E3616A-03C-S

S E R V I C E N O T E

E3616A - Lab Bench DC Power Supply

POSSIBLE SHOCK HAZARD

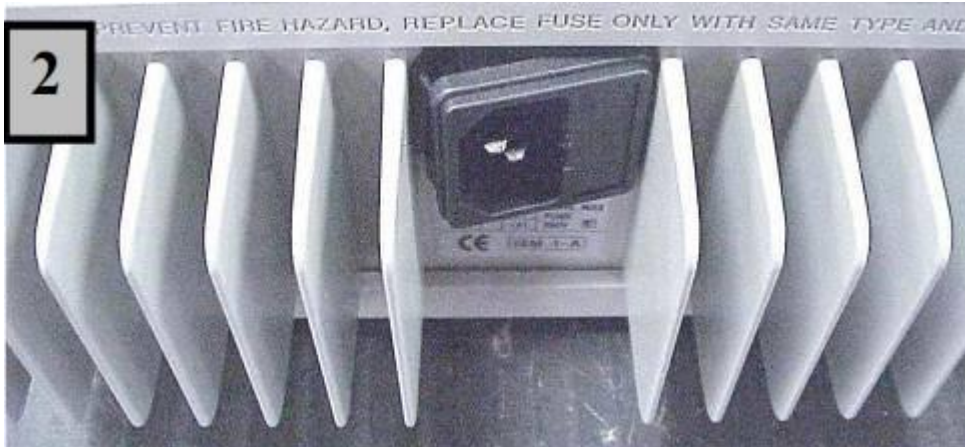
If the AC line cord is forcefully pulled in a side-to-side direction the AC module can be pulled out of the rear heat sink, exposing the conductors that carry AC line voltage.

LOOSE AC MODULE

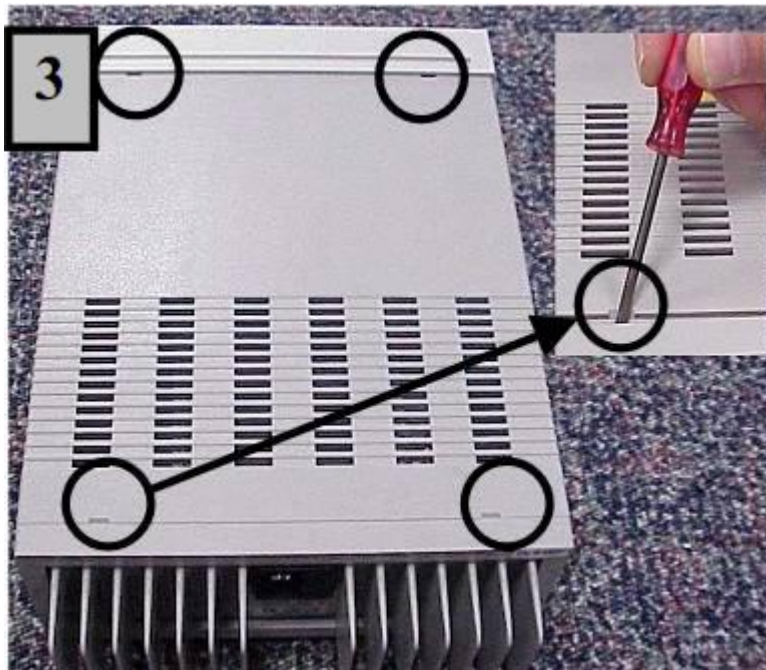
**CAUTION: TEST FOR LOOSE AC MODULE**

1. Make sure line cord is removed from outlet.
2. With line cord securely inserted in AC module as shown, pull forcibly (2 times) in direction of arrow.

1. If the AC module pulls out from unit as shown it will need to be replaced.
2. If the AC module remains in place it does not need to be changed. Put a mark on the AC input label in the lower left hand corner with indelible ink to indicate that AC module has been checked. This label can be found below the AC module.

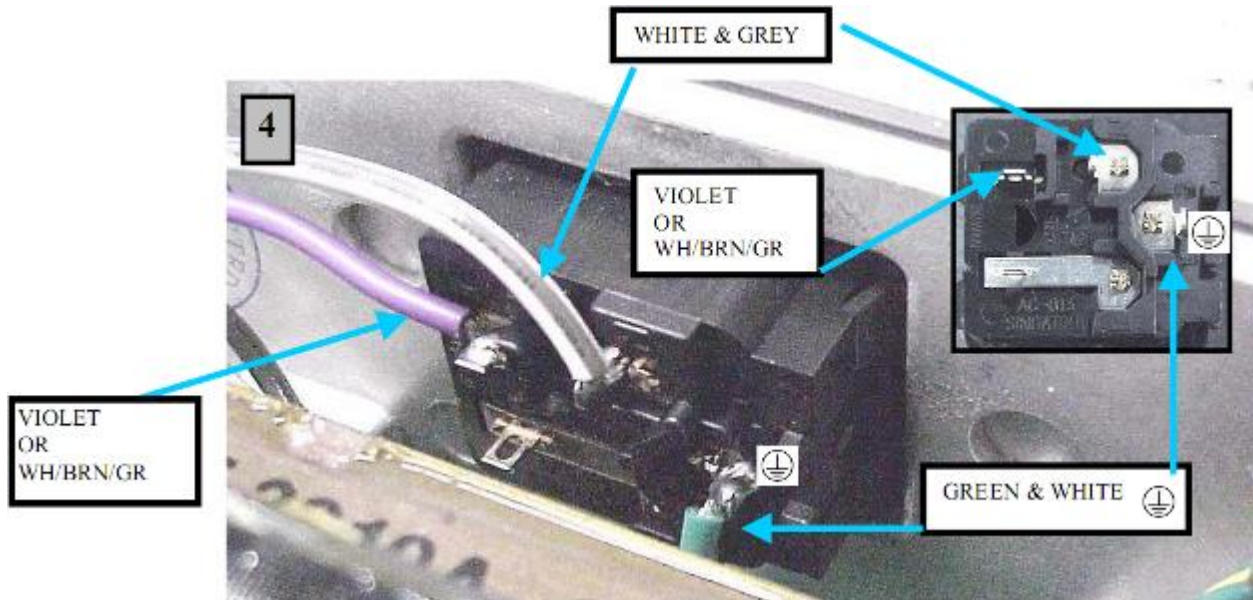
REMOVE COVER by prying rear bezel and front panel away from cover in four places as shown. Then lift cover off unit.

REPLACE MODULE with P/N 5065-6978. Before soldering perform “TEST FOR LOOSE AC MODULE” as shown in the picture above. This will confirm that the new module is secure. Solder wires and **REPLACE FUSE**.

100/120 VAC input - use fuse P/N 2110-0702 (2 amps, 250 volts) E3610/11/12/14/15/16/17/20A
 100/120 VAC input - use fuse P/N 2110-0918 (1.6 amps, 250 volts) E3630A only
 230 VAC input - use fuse P/N 2110-0599 (1 amp, 250 volts) E3610/11/12/30A
 230 VAC input - use fuse P/N 2110-1346 (1 amp, 250 volts) E3614/15/16/17/20A

CAUTION: WIRING MUST BE CORRECT OR HEAT SINK COULD BE AT LINE POTENTIAL.

CAUTION: MAKE SURE SAFETY GROUND  IS ATTACHED TO HEAT SINK.
